Addendum No. 1
May 30, 2023

Project: Dell Rapids City and Community Hall
317 E 4th ST Dell Rapids, South Dakota
Architecture Incorporated Project #2999

Architect: Architecture Incorporated

UNDERFLOOR PLAN - PLUMBING

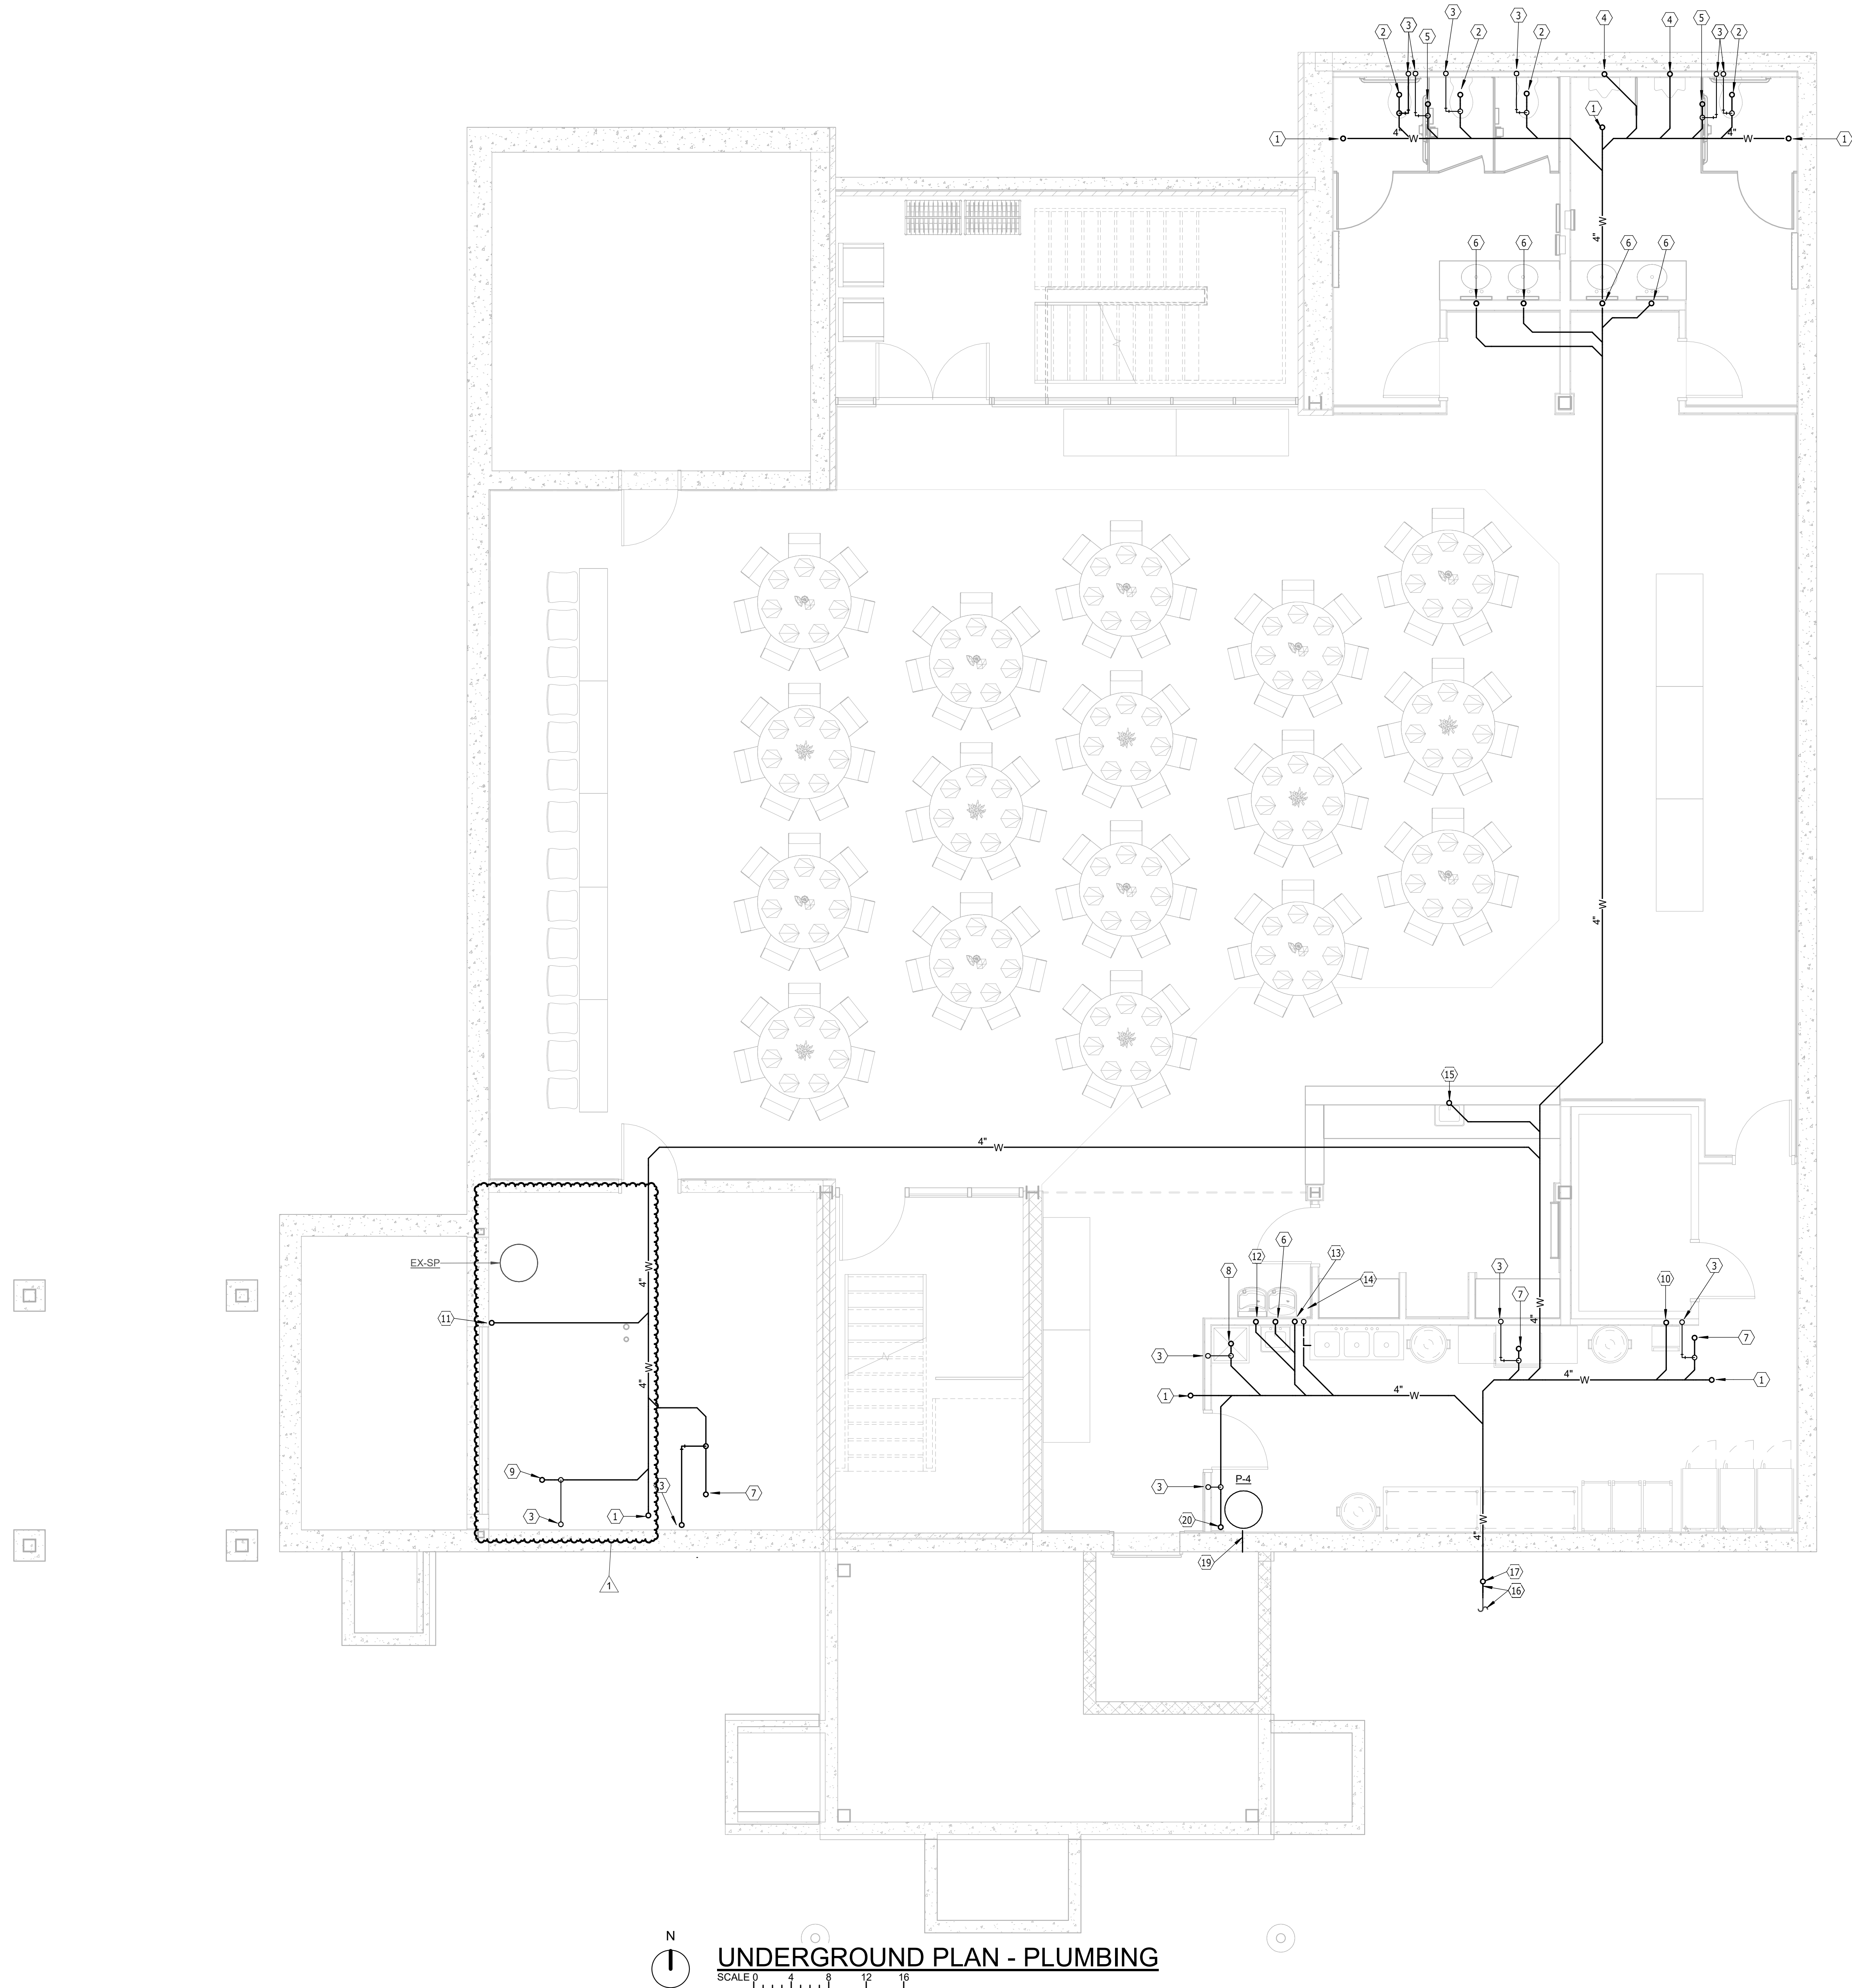
See Revised Drawing Sheet 8.30, items labelled "1 – ADDENDUM 1", dated 5-26-23.

- 1) Revise 4" W to FSK underneath water meter location to match new water service entrance location. Revise 2" V piping as shown.
- 2) Extend 4" W main piping in mechanical room to the South wall of the room. Locate cleanout at South wall.

BASEMENT FLOOR PLAN - PLUMBING & HEATING

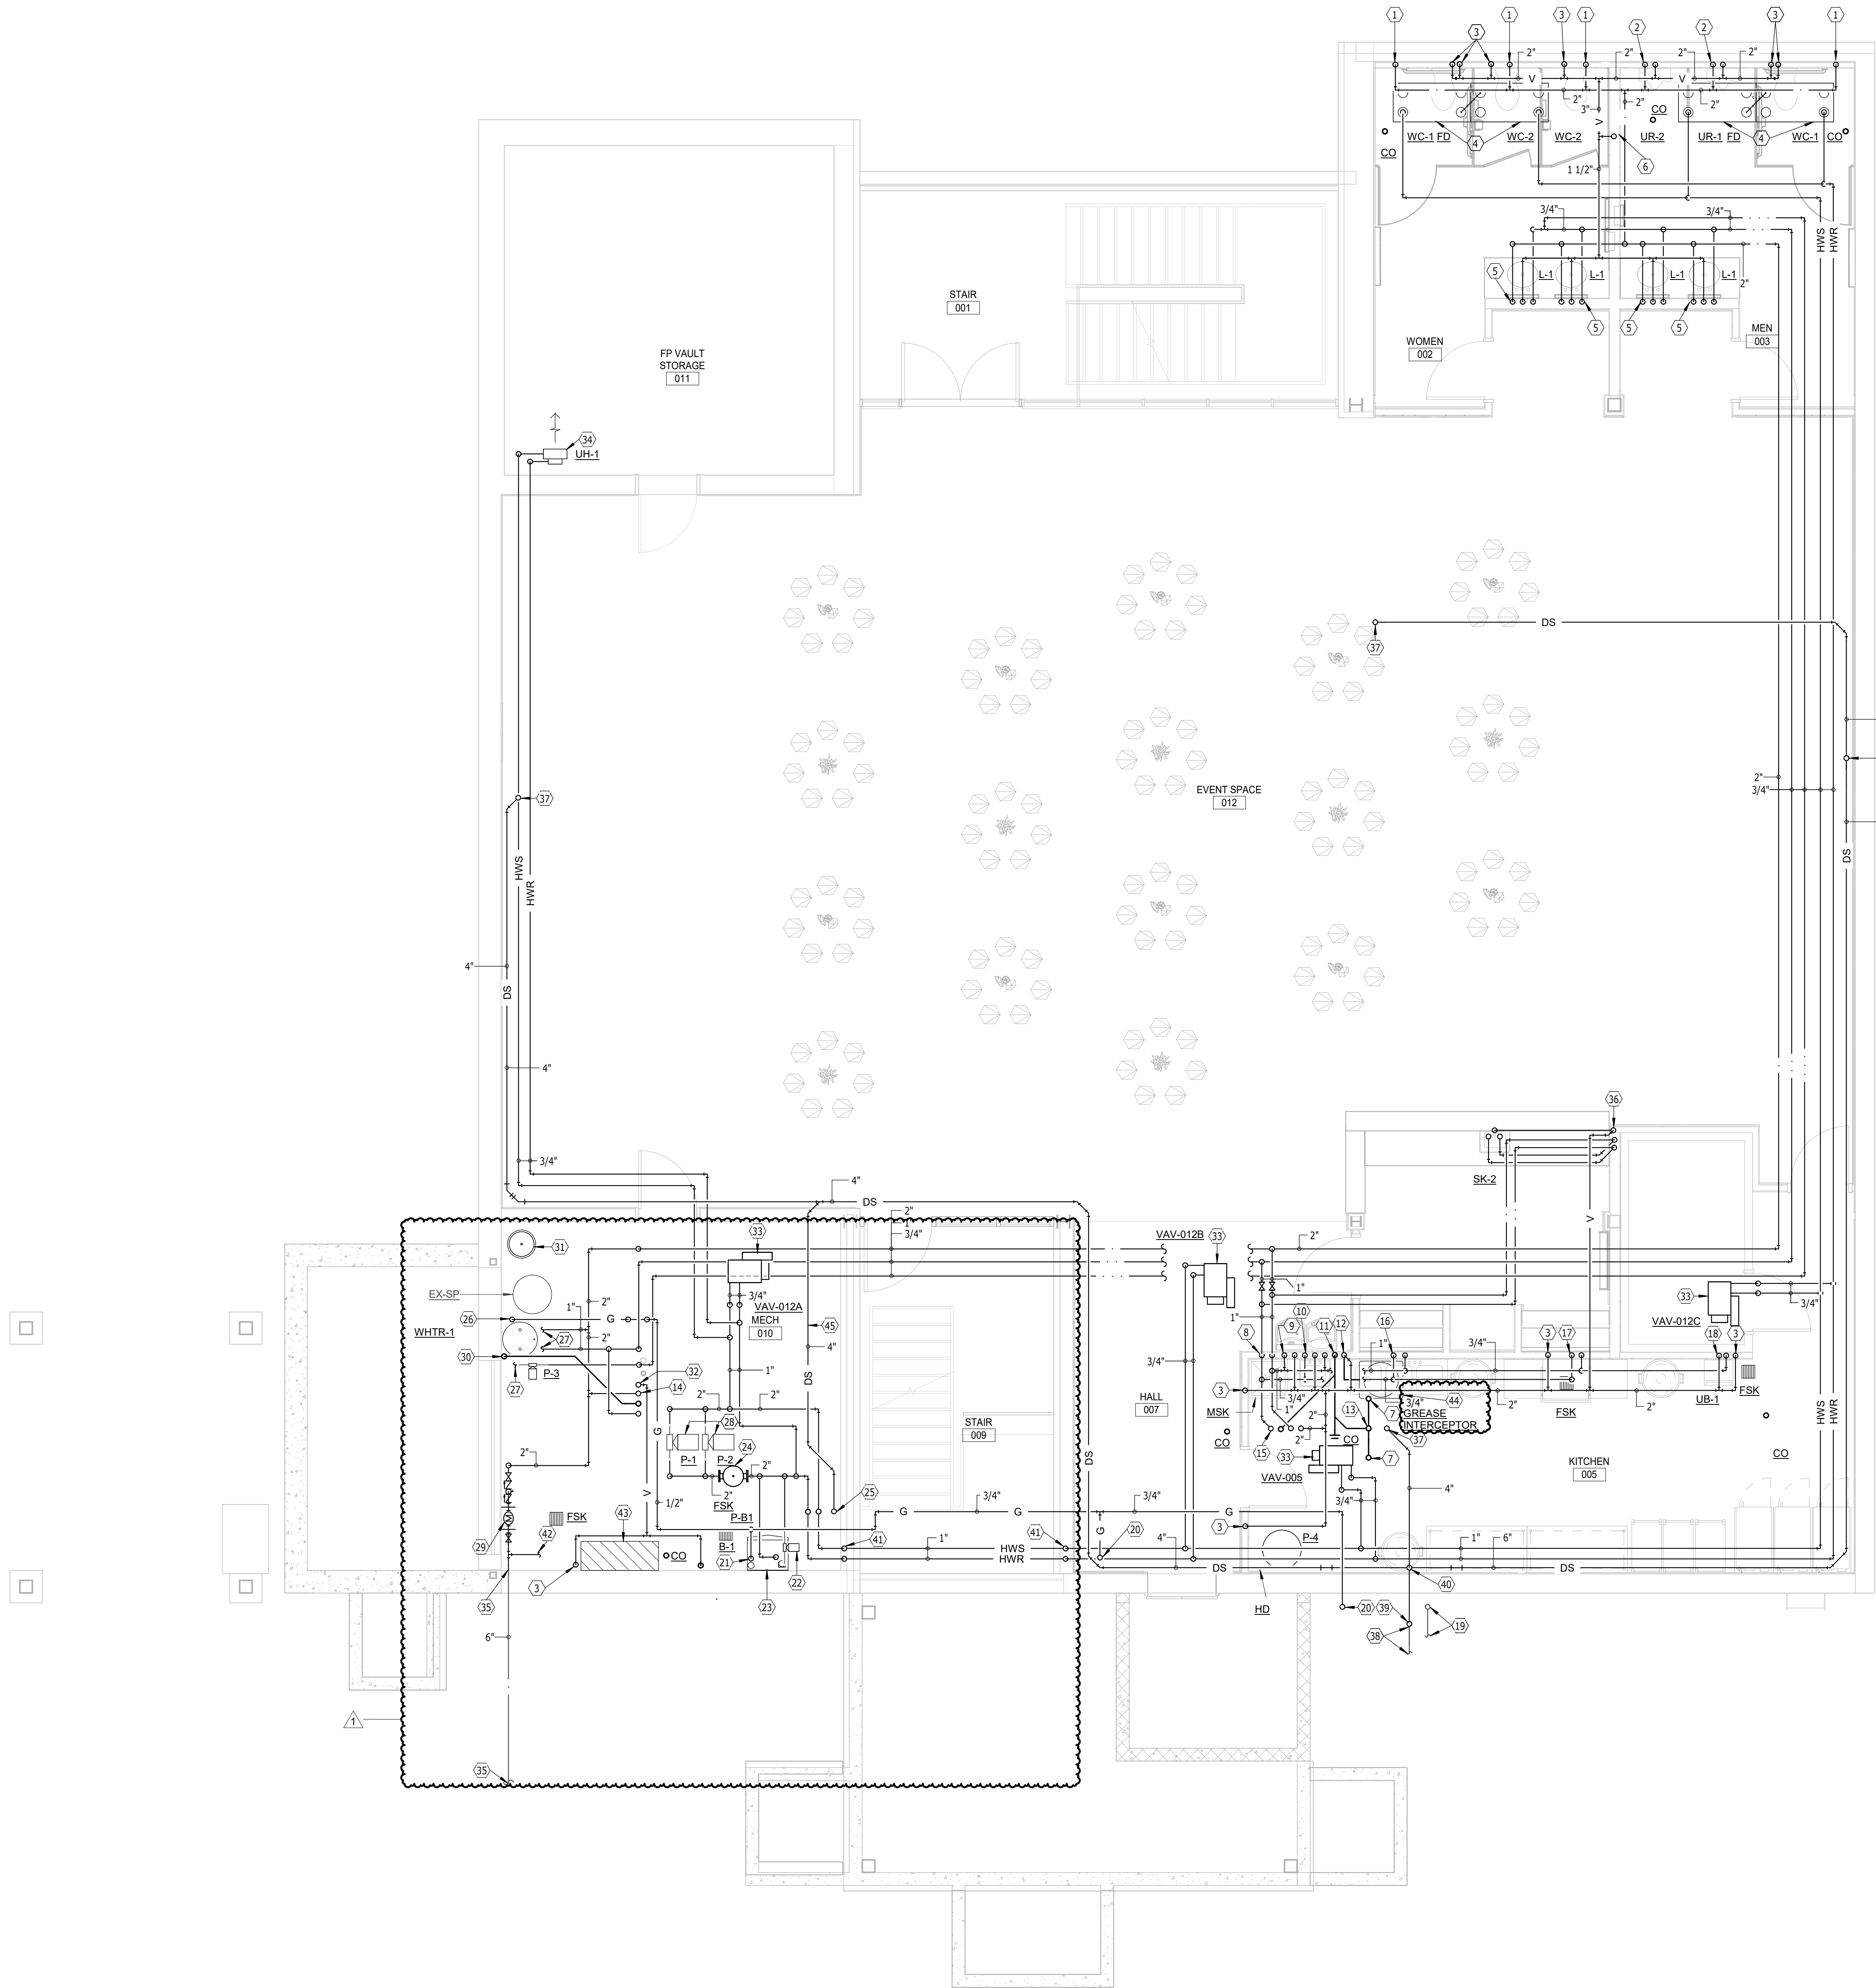
See Revised Drawing Sheet 8.31, items labelled "1 – ADDENDUM 1", dated 5-26-23.

- 1) Revise water service location from 2" to 6" and shall be routed from the South entering the mechanical room in the SW corner of the room.
- 2) Provide tee for 4" fire suppression service and route 4" water to fire suppression riser location now shown on the drawings. See specifications for performance specifications on the fire suppression system.

- 3) Relocate the Heating Water System Expansion Tank to previous water service location.
- 4) Revise CW piping mains within room as shown.
- 5) Relocate P-1 and P-2 to be mounted outside of landing (above room) footprint and hang pumps at 7'-0" AFF.

- 6) 1" HWS/HWR piping crossing STAIR 009 shall drop down in wall, be routed tight to the underside of the stair landing, then rise back up in wall to above ceiling in HALL 007.

- 7) Add keynote to Grease Interceptor. See revised keynote list.
- 8) Relocate FSK underneath the water meter to match new meter location within room. Revise V piping within mechanical room to reflect new FSK location.

- 9) Revise 4" DS piping routing with mechanical room. Route to the North out of the room to combine with other DS piping outside of room. Maintain necessary clearances from electrical equipment located on the East wall of the room.

Catalog Number:
CP3B51119A42PBSP1

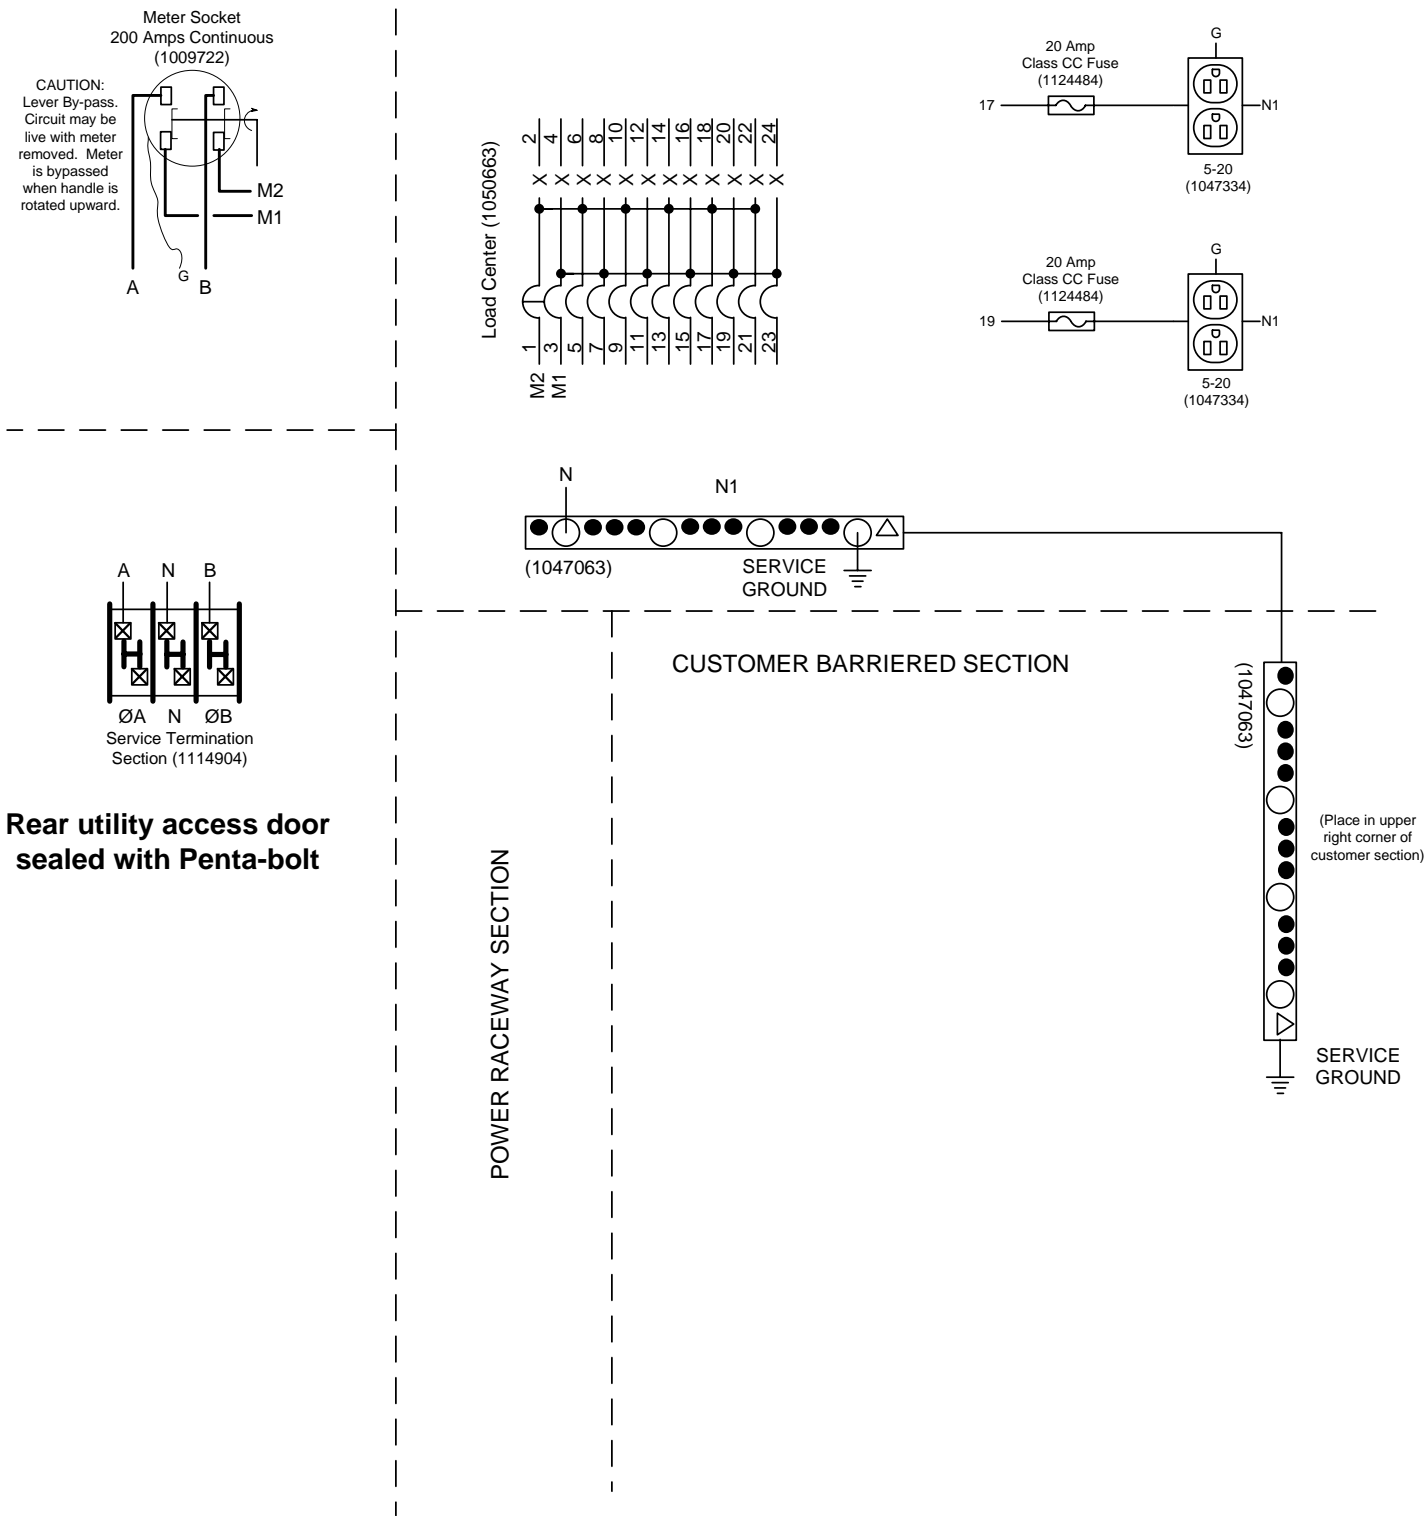
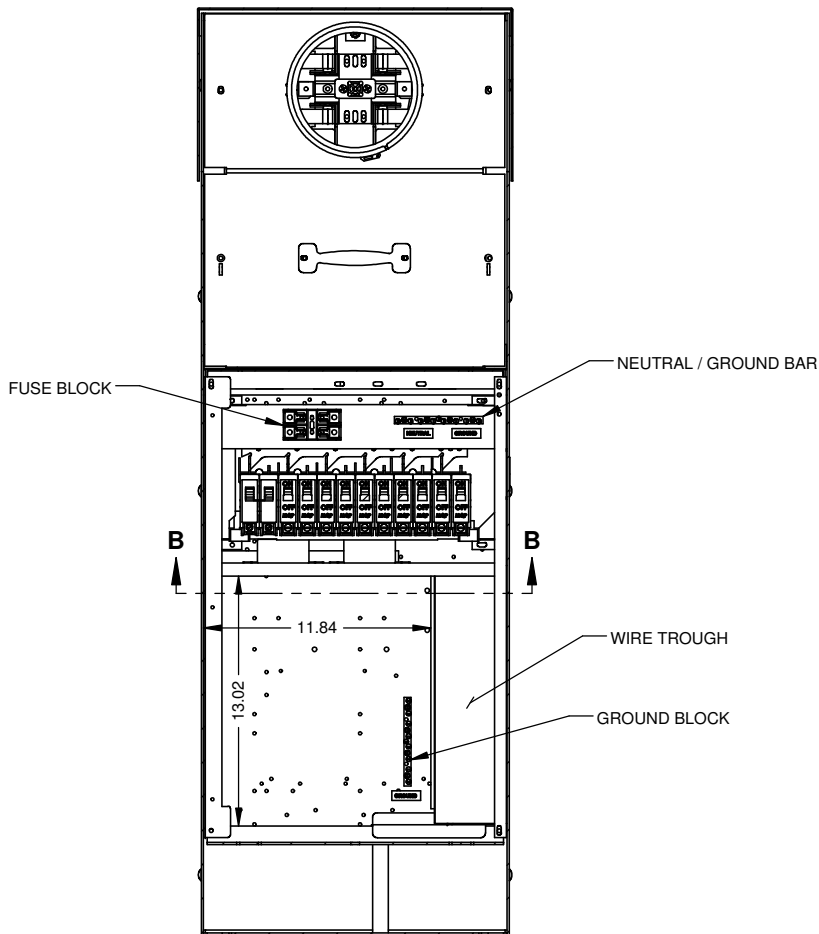
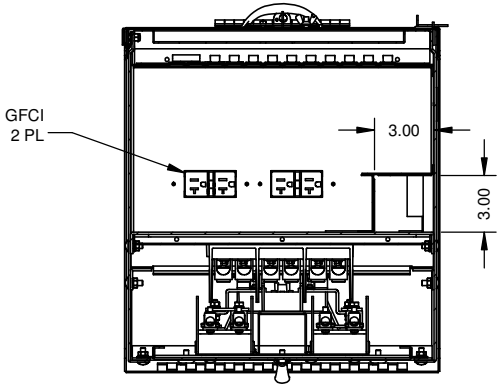
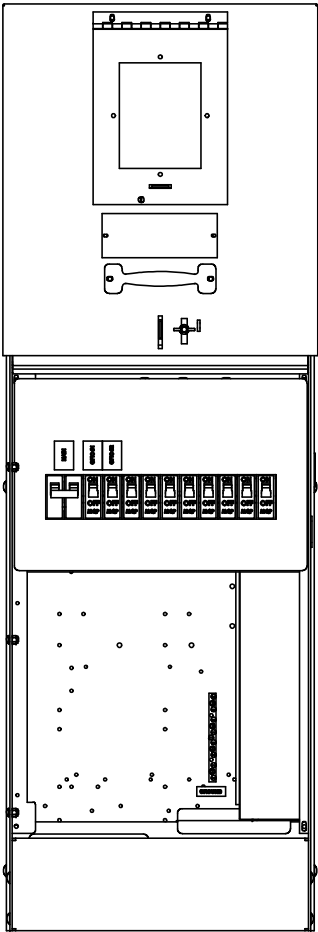
1. See updated Panelboard Schedules for Panelboards A, B and ATM.
2. Service #2 Panel (ATM) to be 100A, not 60A. See Revised Riser Diagram.
3. Supplemental factory drawings for Service #2 Equipment are attached below.
